**BGMU WTP – HIGH SERVICE PUMP NO. 4**  
**FOR**  
**BOWLING GREEN MUNICIPAL UTILITIES**

**ADDENDUM NO. 1**

**ISSUE DATE: July 26, 2021**  
**BID DATE: August 12, 2021**

**BGMU Bid No.: RFB2021-08**  
**SSR No.: 20-41-008.0**

**SKC-1**

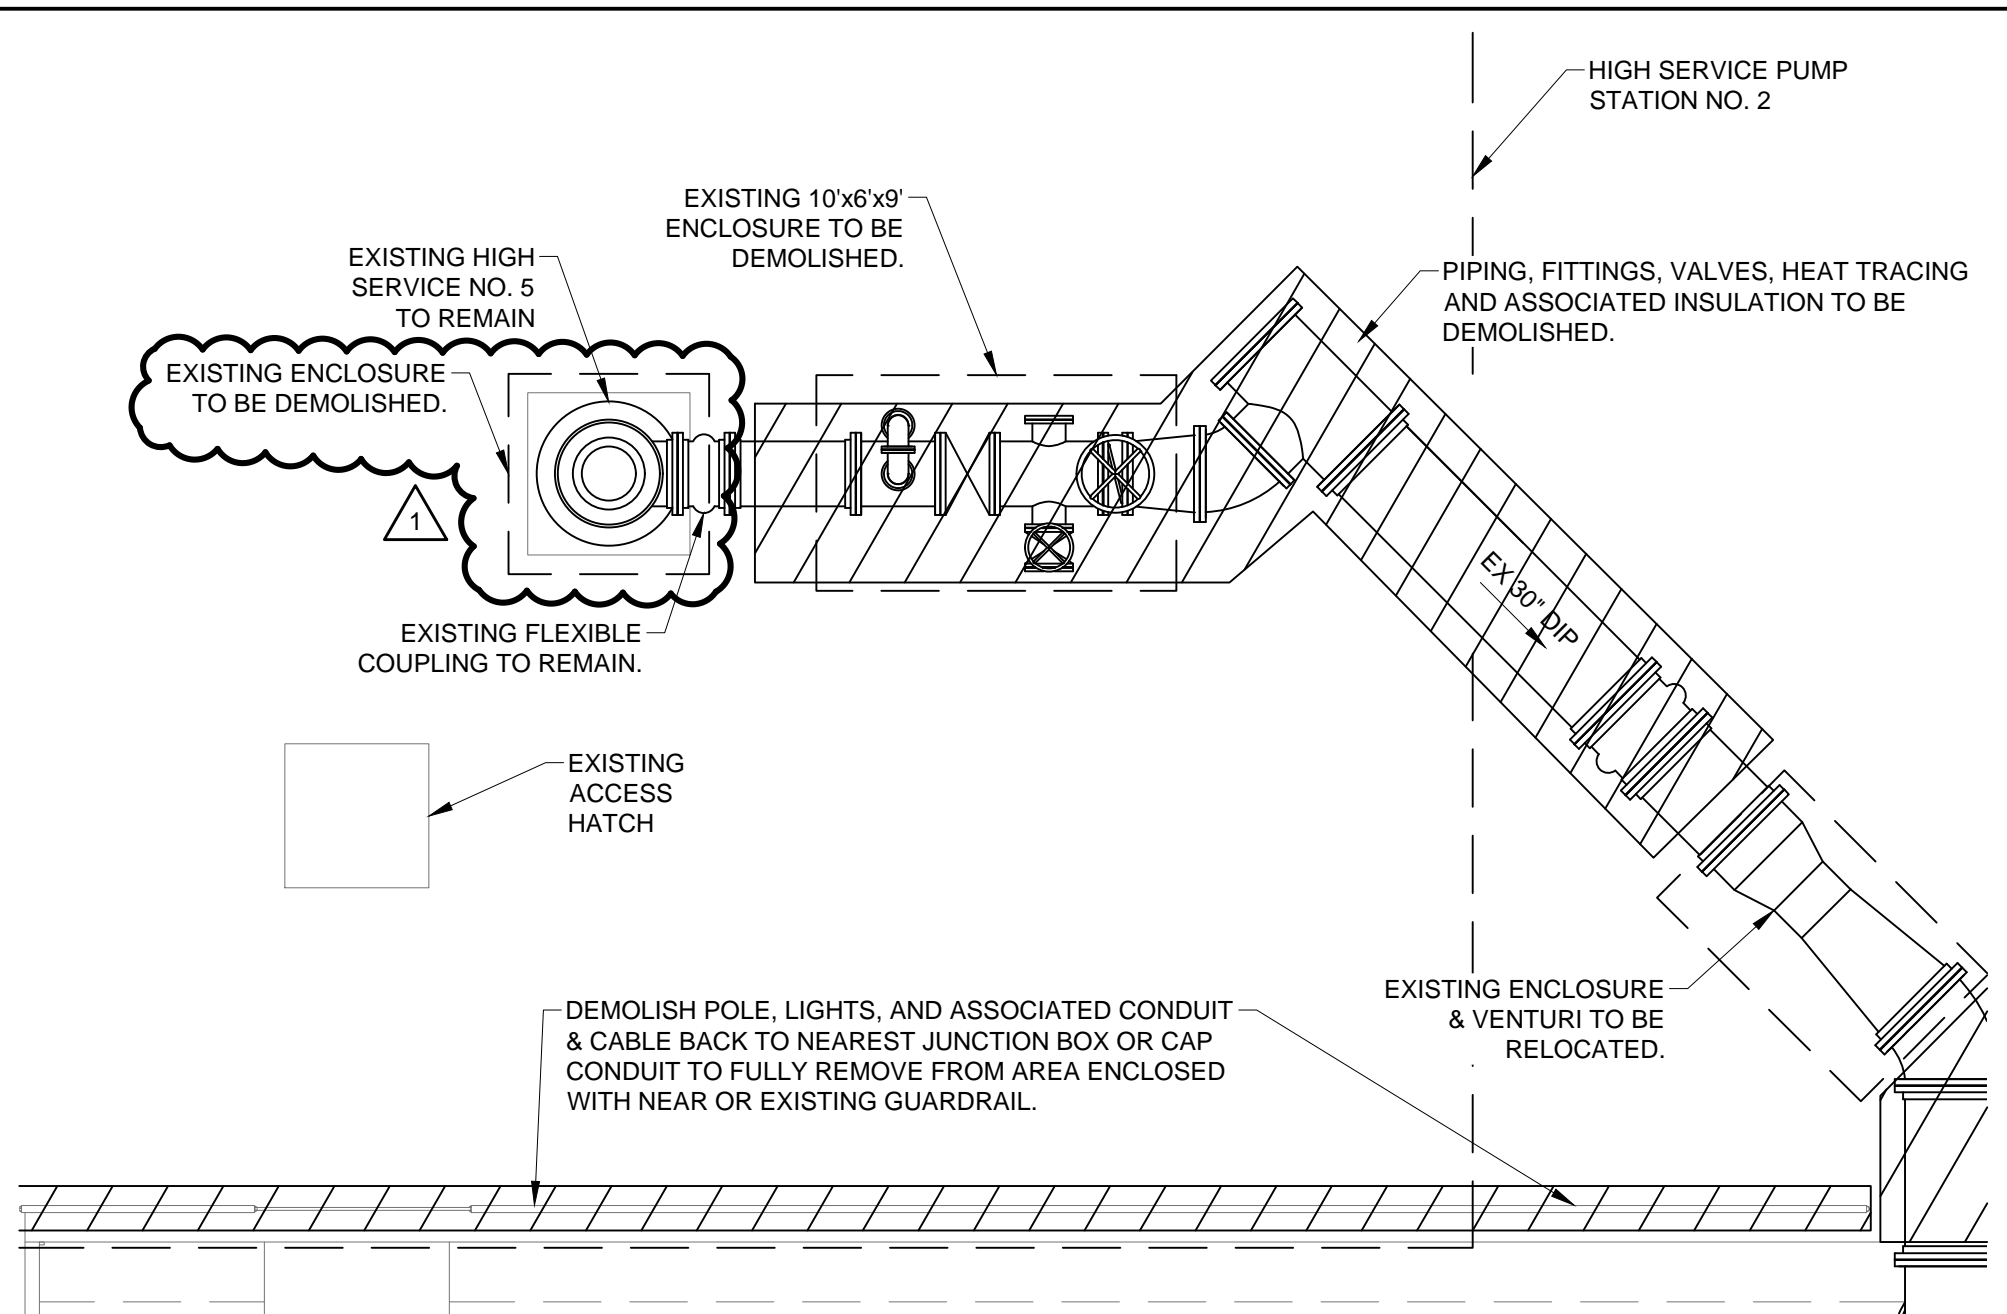
Addendum Item	Page or Drawing	Location and Description of Change
D-1.	CS1.1	<u>Modify</u> staging area as shown on attached Sketch SKC-1.
D-2.	CU1.1	<u>Modify</u> staging area as shown on attached Sketch SKC-1.
D-3.	CU1.1	<p><u>Add</u> the following notes to the drawing:</p> <p><b>“3. CONTRACTOR SHALL PERFORM HYDRO-EXCAVATION TO IDENTIFY LOCATIONS OF EXISTING UNDERGROUND UTILITIES.</b></p> <p><b>4. CONTRACTOR SHALL COORDINATE ALL WORK WITH OWNER REGARDING EXISTING OVERHEAD POWER POLES AND ASSOCIATED GUY WIRES LOCATED IMMEDIATELY ADJACENT TO CLEARWELL NO. 6.”</b></p>
D-4.	DD1.1	<u>Add</u> callout indicating to delete existing High Service Pump No. 5 enclosure as shown on attached Sketch SKD-1.
D-5.	DD1.1	<p>At center of page <u>delete</u> note “DEMOLISH POLE, LIGHTS, AND ASSOCIATED CONDUIT &amp; CABLE BACK TO NEAREST JUNCTION BOX OR CAP CONDUIT TO FULLY REMOVE FROM AREA ENCLOSED WITH NEAR OR EXISTING GUARDRAIL.” and <u>replace</u> with the following:</p> <p><b>“FOR AREA ENCLOSED WITH NEW AND EXISTING GUARDRAIL, DEMOLISH ALL POLES, LIGHTS, METAL AND CONCRETE BASES, AND ASSOCIATED CONDUIT AND CABLE BACK TO NEAREST JUNCTION BOX AND CAP ALL CONDUIT.”</b></p>

- i. Disposal of Waste – This will be the full responsibility of the Contractor. All material must be legally disposed of.
- j. Staging Areas – Staging areas are shown on drawings. The Owner said that the staging area currently shown on the drawings needs to be modified to allow for truck access. **Subsequent to the meeting, SSR adjusted the staging to allow for truck traffic to go around the clearwell. This change will appear on Drawings CS1.1 and CU1.1 as part of Addendum No. 1.**
